SI B17 01 18
Cooling Systems

HEATER HOSE IS CONTACTING THE STEERING SHAFT

This Service Information bulletin replaces SI B17 01 18 dated April 2018

G12 (740 Li and 740 Li xDrive Sedans)	G30 (540i and 540i xDrive Sedan)	G32 (640 xDrive GT)	
---------------------------------------	----------------------------------	---------------------	--

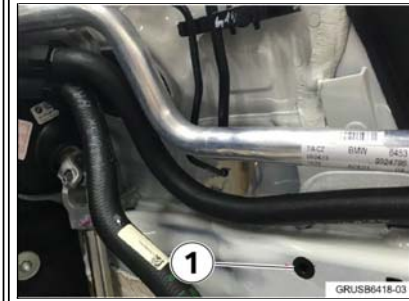
The steering shaft can contact the heater hose, possibly wearing through the hose.

- Install a hose retaining bracket to position the hose away from the steering shaft.
- Replace the heater hose if already damaged.
